University of New England
Revised Motions for Planning Board Report #60-00
11-14-00

On July 13, 2001, the Planning Authority granted approval for an amendment to the approved site plan for the University of New England campus on Stevens Avenue. The approved revision includes leaving the northerly most on-site Stevens Avenue curb cut and driveway apron in the pre-development condition. All other improvements will be constructed according to the previously approved site plan.

to: Bill Needleman, City of Portland
from: Sarah Marshall, tj&a SM
re: UNE Westbrook College
attmt: partial site plan

RE: UNE Parking Lot, Design Revision

GRANITE CURB MATCH TO EXIST. IN STREET.
 tjd&a 7.9.07
 COLLEGE OF HEALTH PROFESSIONS
 VNE - WESTBROOK COLLEGE
 PARTIAL VIEW / COPY OF
 SKC-13 / SITE & UTILITY PLAN

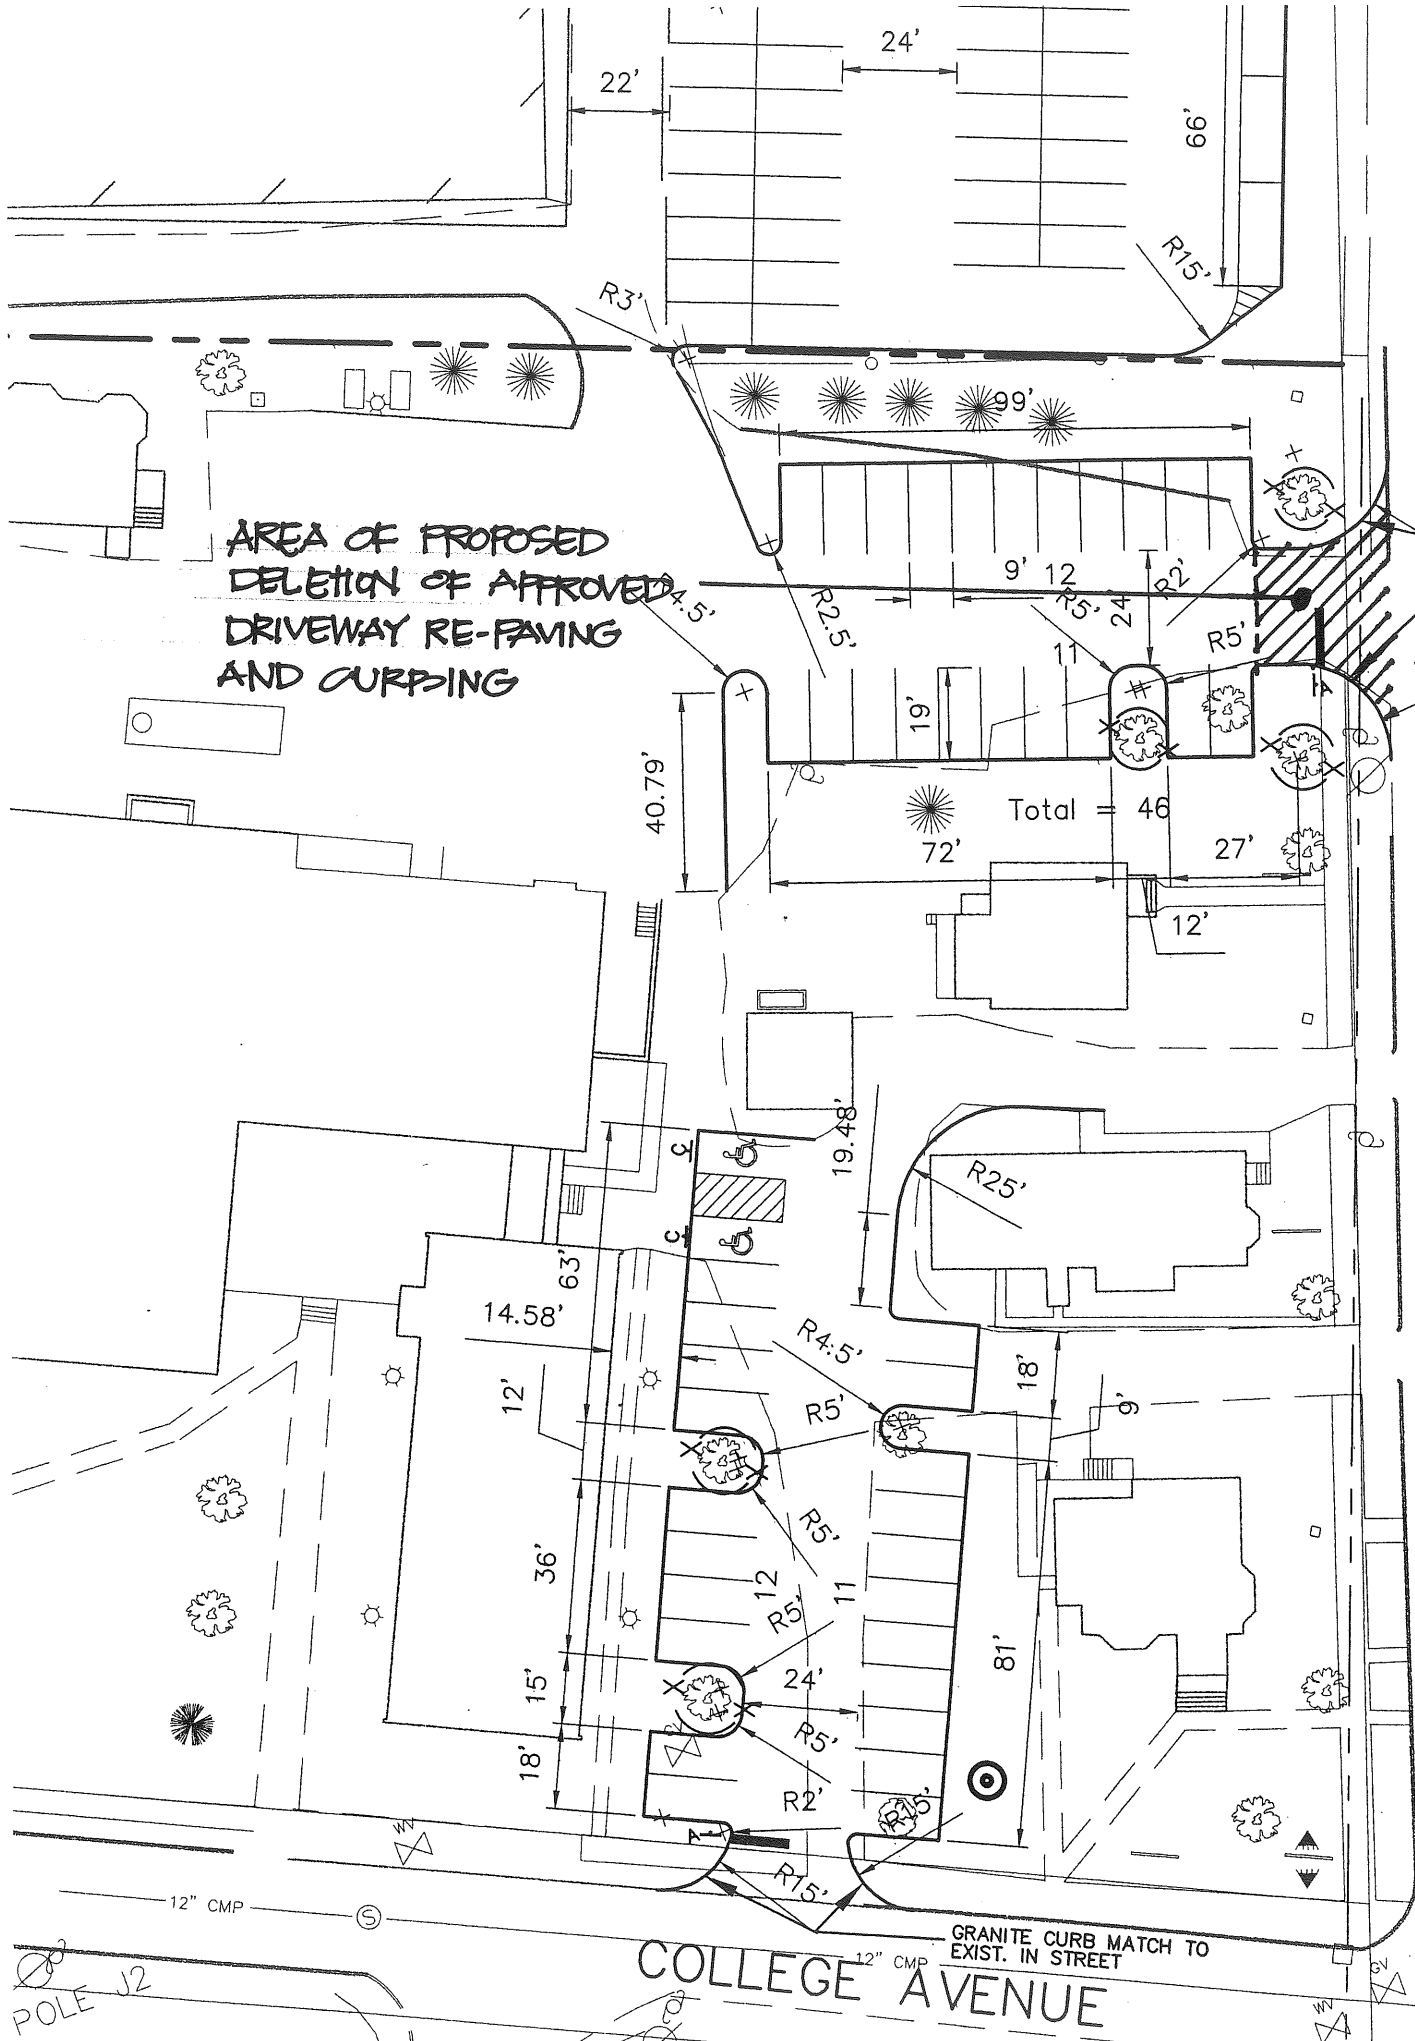
Please take a look at the attached plan which shows the driveway to the UNE Westbrook campus just west of the the Armory on Stevens Ave.

UNE proposes to delete the site work in this area due to value engineering. The proposed re-paving and re-striping of the lot will take place, but the re-paving and re-curbings of the existing driveway will not. Having reviewed the site and the plans, I do not see issues of accessibility or drainage or circulation which will be adversely affected by deleting the driveway improvements.

AREA OF PROPOSED
 DELETION OF APPROVED
 DRIVEWAY RE-PAVING
 AND CURPING

trees cut in
proposed alternative

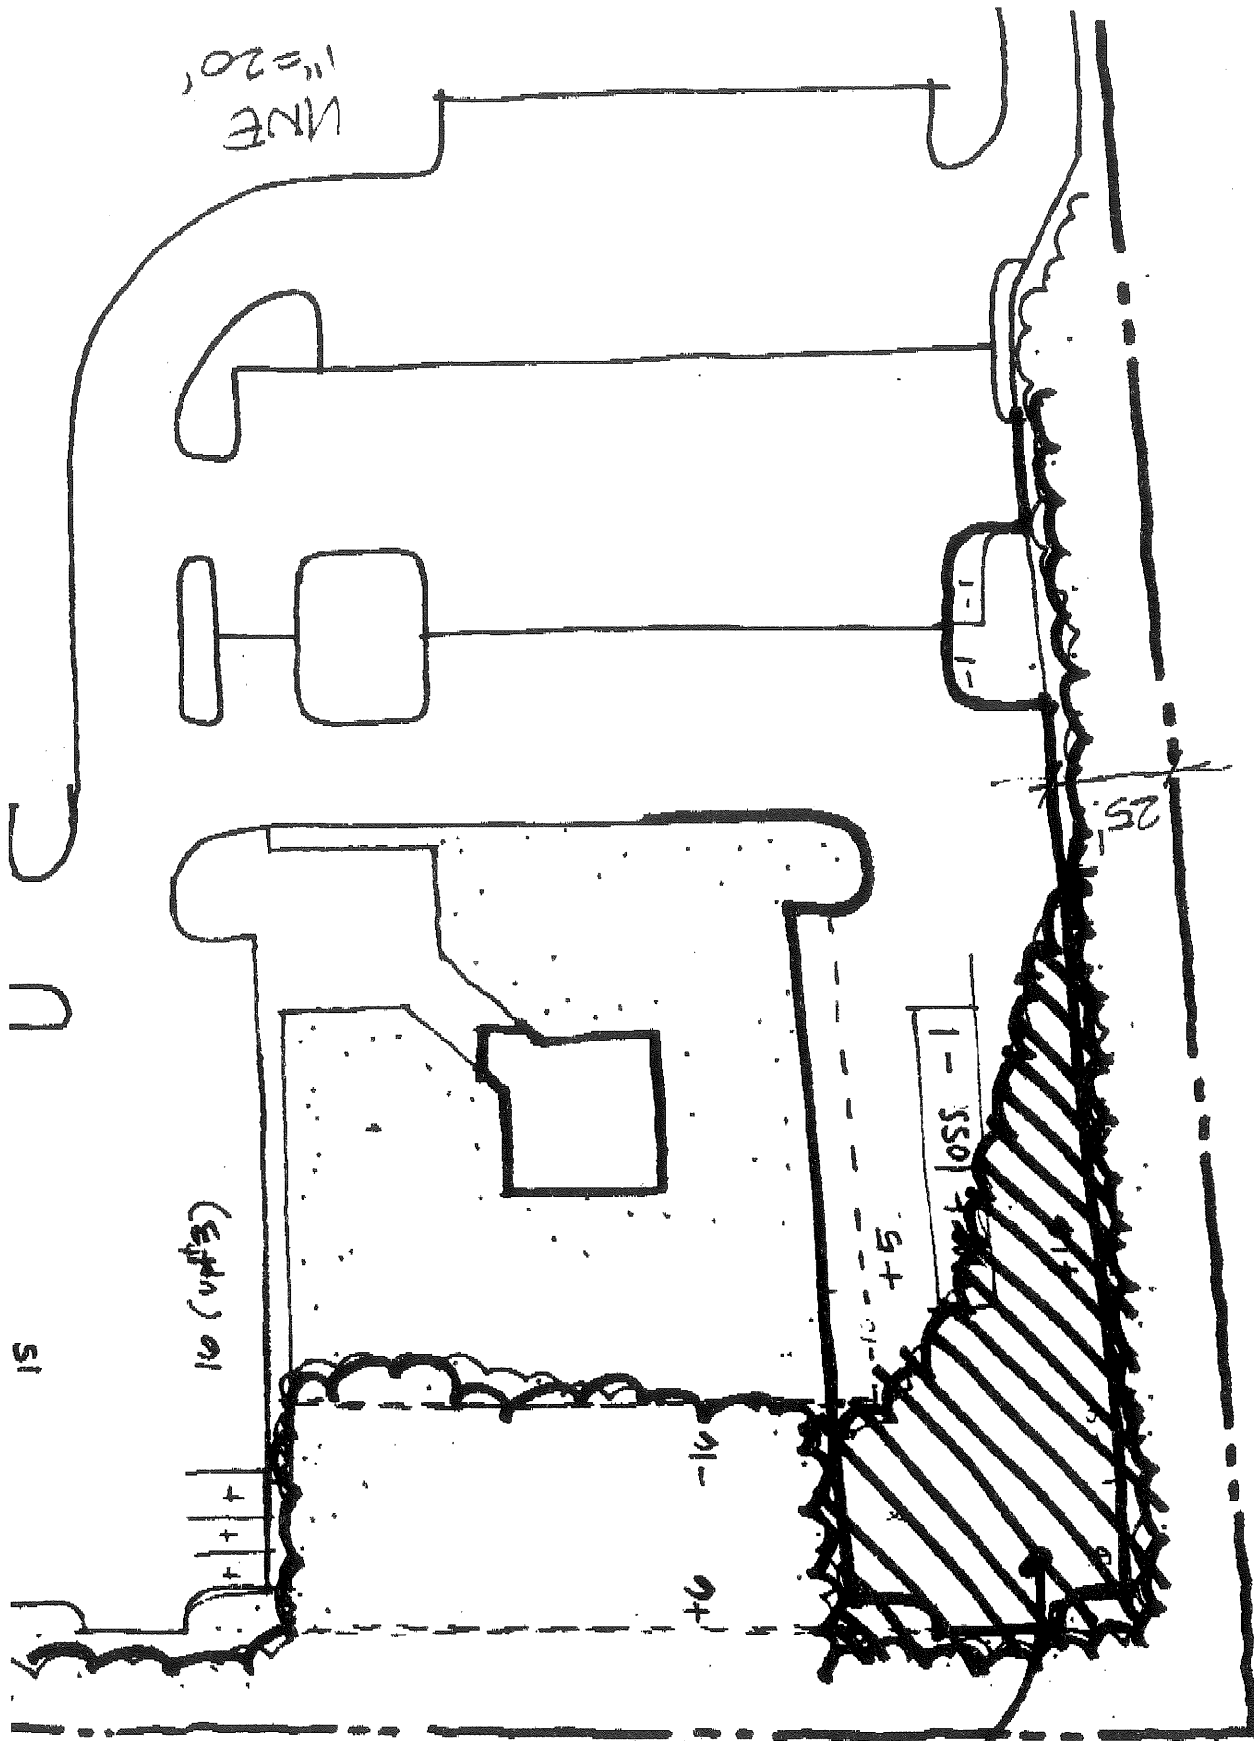
This letter is to confirm the revision to the approved site plan for the University of New England campus on Stevens Avenue. The approved revision includes the redesign of parking areas around the art gallery to the rear of the campus. The approval is subject to the following condition:

That prior to any clearing or construction, the City's Development Review Coordinator will field verify the 25ft preservation buffer dimension from the southern and western property line. This preservation area must be staked with snow fencing or similar material, prior to any earthwork or construction.

TREES CUT IN
PREVIOUSLY SUBMITTED
PLAN

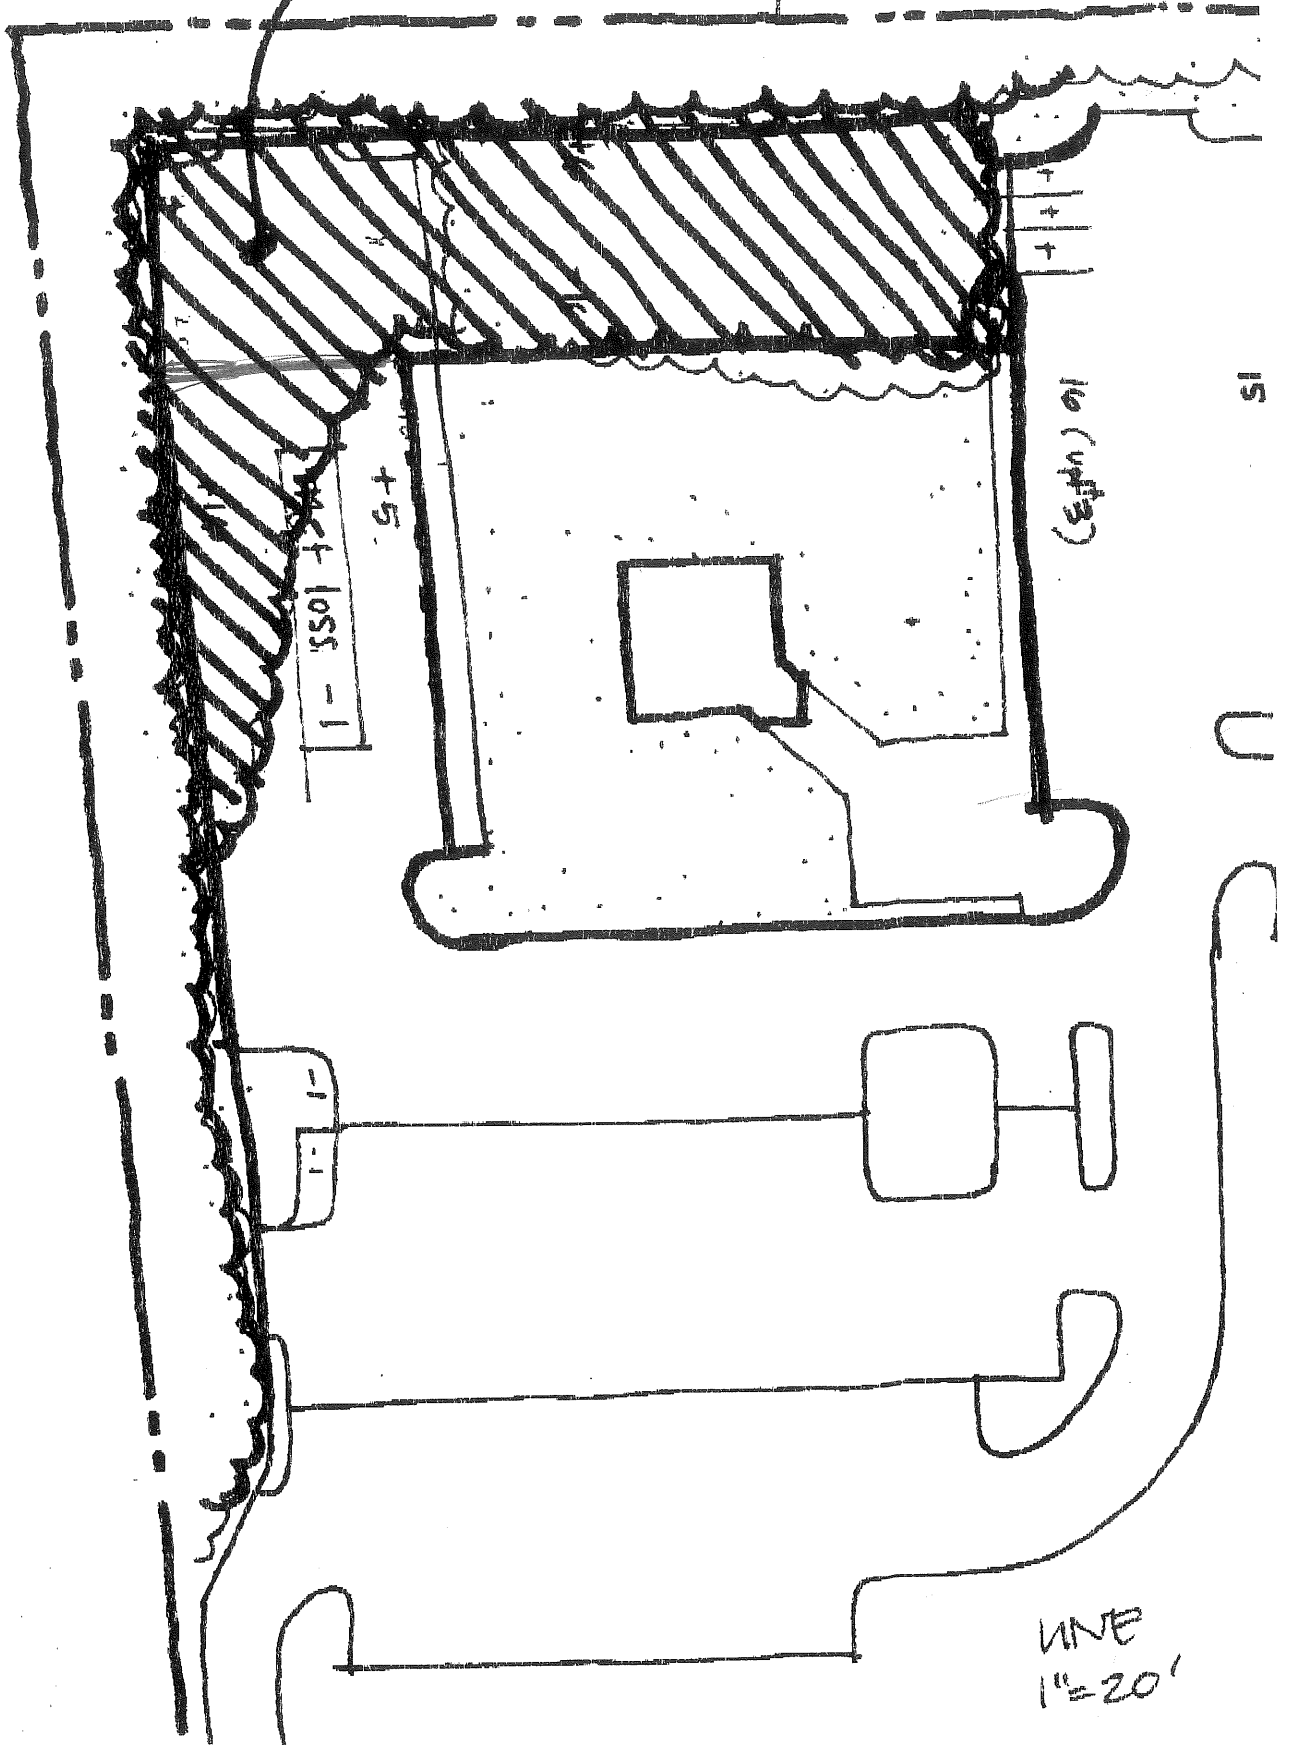
This letter is to confirm the revision to the approved site plan for the University of New England campus on Stevens Avenue. The approved revision includes the redesign of parking areas around the art gallery to the rear of the campus. The approval is subject to the following condition:

That prior to any clearing or construction, the City's Development Review Coordinator will field verify the 25ft preservation buffer dimension from the southern and western property line. This preservation area must be staked with snow fencing or similar material, prior to any earthwork or construction.

REVISIONS	PROPOSED DRAINAGE	
	UNIVERSITY OF NEW ENGLAND PORTLAND, MAINE	
	JOB NO.: 2000-031	DATE: 3/9/00
	SCALE: 1"=100'	
	DRAWN BY: JBW	CHECKED BY: NGC
SHEET NO. 1 OF 1

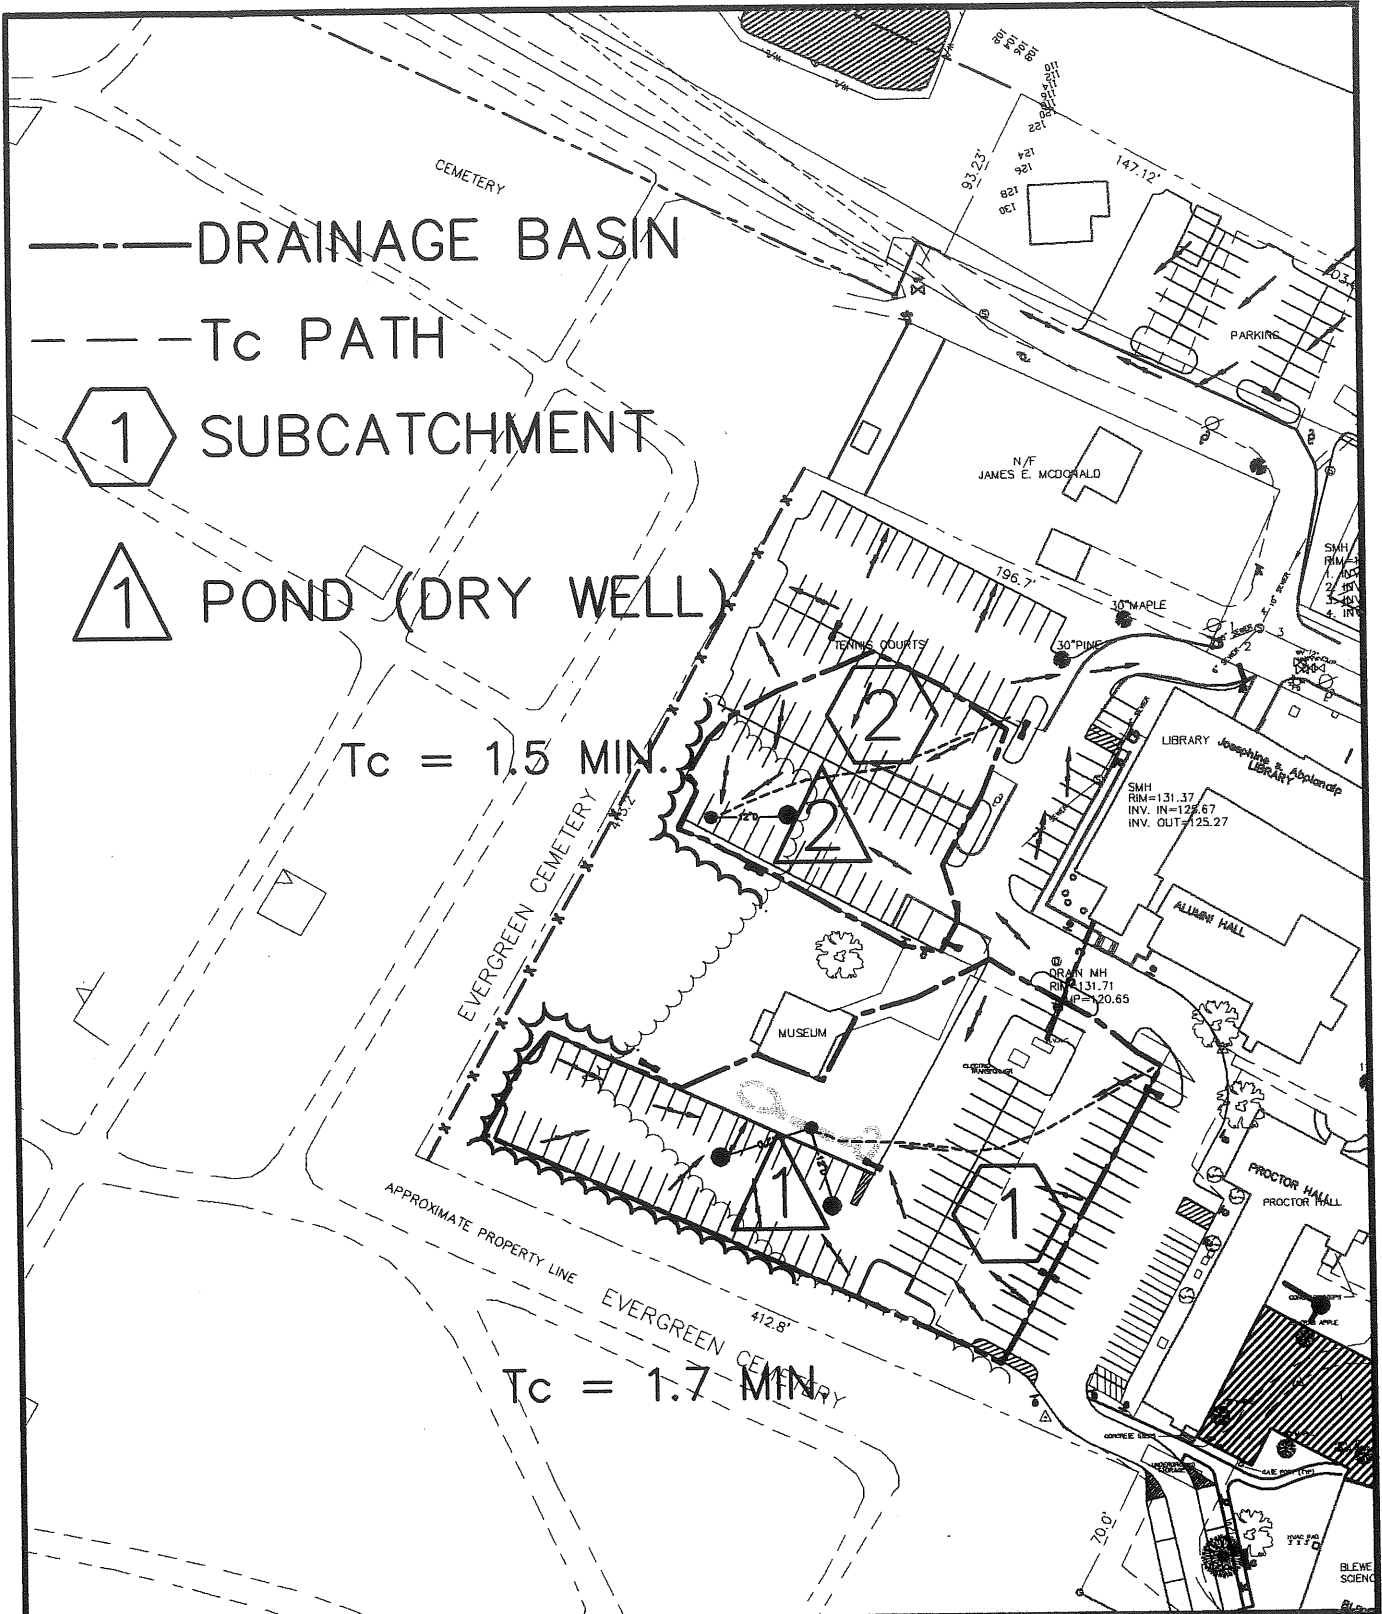
In response to the changes in the parking lot configuration in the vicinity of the museum, the stormwater calculations have been re-run for the proposed conditions. The reconfiguration has resulted in a smaller impervious area over the site and allows for a substantial group of sizable trees to remain on the site to the west of the museum building.

The reconfigured parking lot is shown on the attached sheet 1. The stormwater from both drainage areas will be collected by catch basins and conveyed to dry wells under the parking lot. The catch basins will act as settling basins for the larger grits and floatables that may run off the parking lot and prevent them from entering the dry wells.

The entire runoff from the two-year storm will be stored in the dry wells and discharged into the ground. A portion of the runoff from the 10- and 25-year storm events will flow from the site to the cemetery adjacent to the site. The table below shows the runoff rates for the proposed and existing conditions. The figures for the existing conditions were taken from the original drainage study dated October 26, 2000.
